# Site Accessibility Evaluation

**Human Services 17 N.  
Spruce**

**17 N Spruce St  
Colorado Springs, CO  
80905**

**Accessibility Evaluation**

### Finding: 1

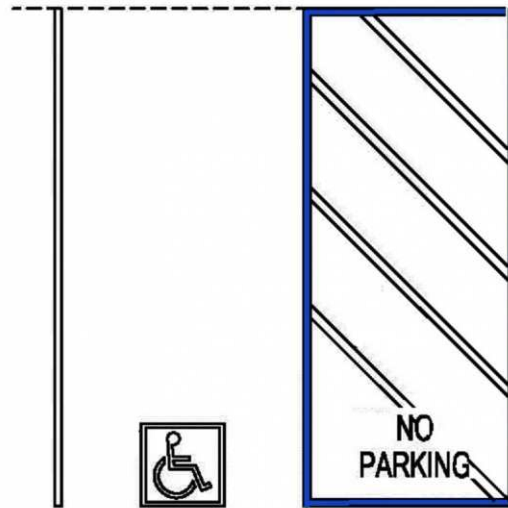
The striping and markings for the accessible parking stall's, loading/unloading access aisle are dilapidated and in need of repair and/or maintenance.

Access aisle and accessible parking stalls striping barely visible

Re-stripe parking lot to include 2 accessible parking stalls, 2 van accessible parking stalls, van access aisle and the international symbol of accessibility on the accessible parking stalls.

### Finding: 3

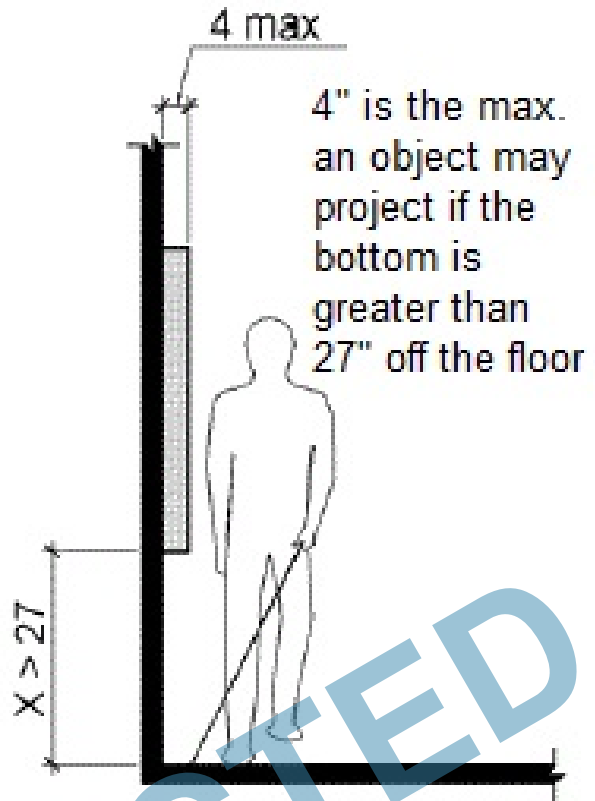
The shrub projects more than 4 inches into the exterior circulation path of travel.

Shrub protrudes into exterior circulation path

Trim brush to meet ADA compliance.

### Finding: 5

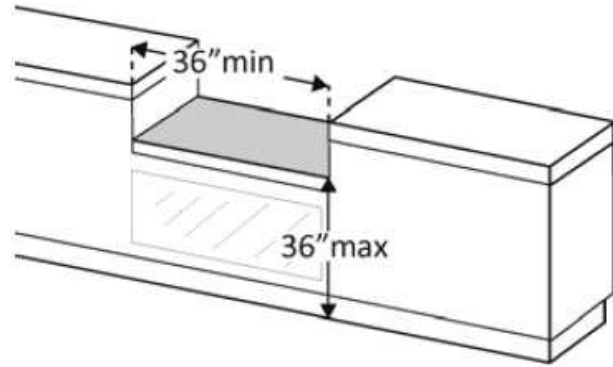
The transaction counter is too high.

42 inches high above  
finished floor

Install new counter section that measures 36 inches maximum in height from the finish floor and lengthen that section of the counter to 36 inches minimum. A clear floor or ground space shall be provided for either a parallel or forward approach complying with section 305 and/or 306 respectively.

### Finding: 6

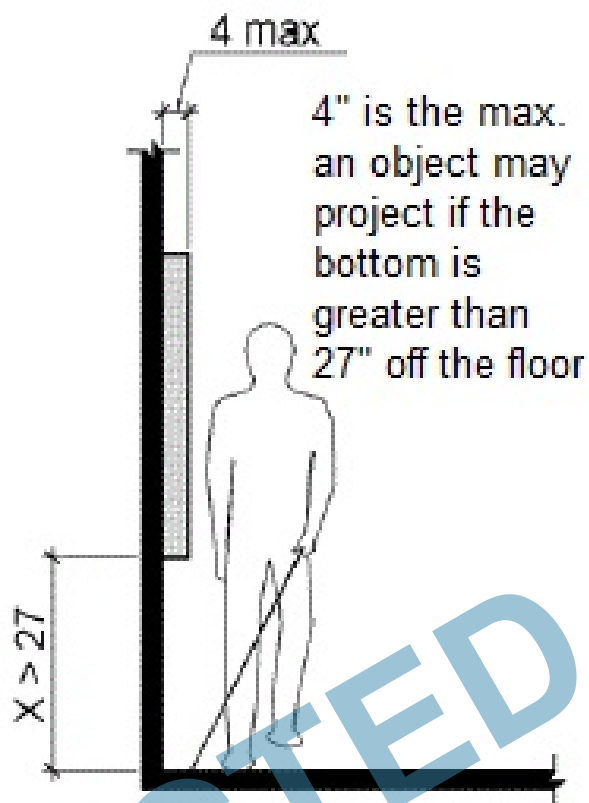
The drinking fountain projects more than 4 inches into the circulation path.

Drinking fountain  
protrudes 19 inches  
from the wall

Replace drinking fountain with new drinking fountain due to fountain skirt no longer manufactured.

### Finding: 8

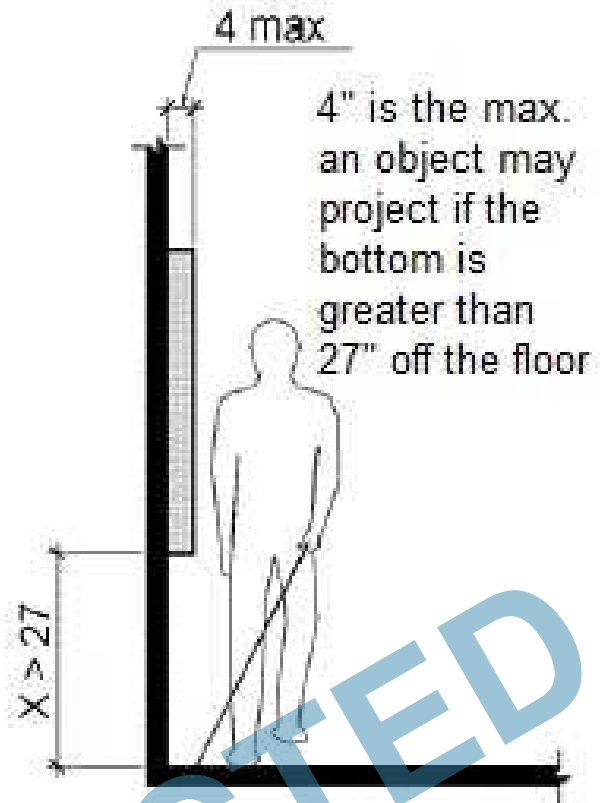
The AED defibrillator projects more than 4 inches into the circulation path.

AED defibrillator enclosure protrudes 7.25 inches into circulation path

Re-locate defibrillator to a maximum height of 27 inches from the bottom edge of the casing to the finished floor or recess defibrillator housing into wall and ensure casing protrusion is no more than 4 inches.

### Finding: 9

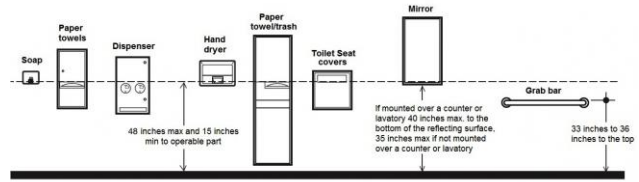
The paper towel dispenser's operation mechanism is too high off the floor.

Operable part is positioned at 53 inches above finished floor

Lower paper towel dispenser a minimum of 6 inches.

### Finding: 10

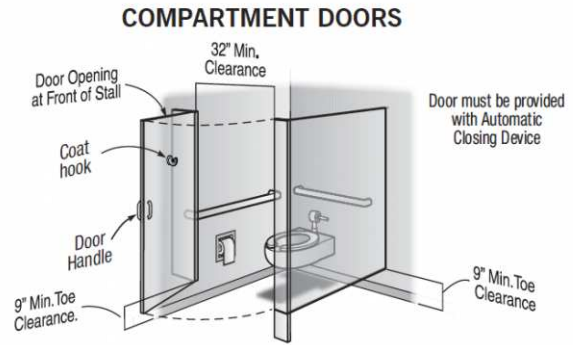
The compartment door is not self closing.

Stall compartment  
door not self closing

Re-adjust or replace door hinges to ensure door is self closing.

### Finding: 12

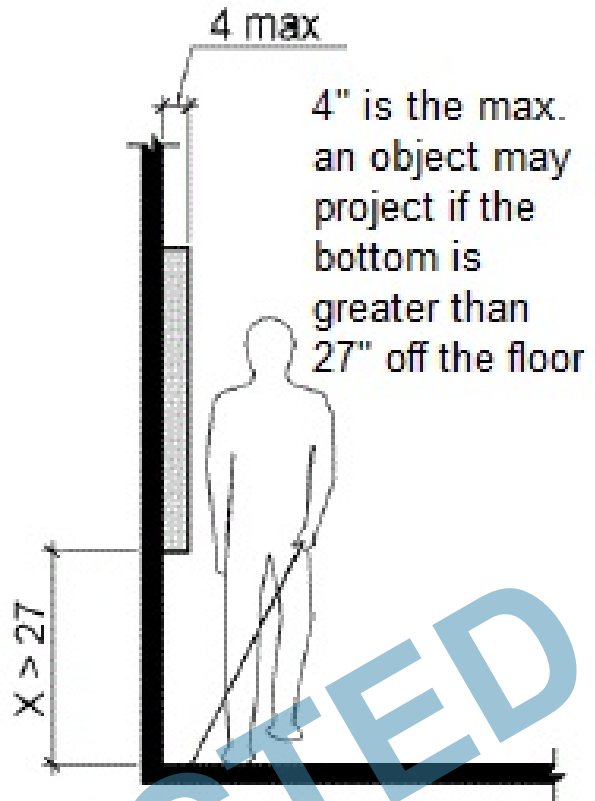
The paper towel dispenser projects more than 4 inches into the circulation path.

Paper towel dispenser  
protrudes 9.5 inches  
into circulation path

Re-locate paper towel dispenser near lavatory and ensure operable part is no greater than 48 inches above finished floor.
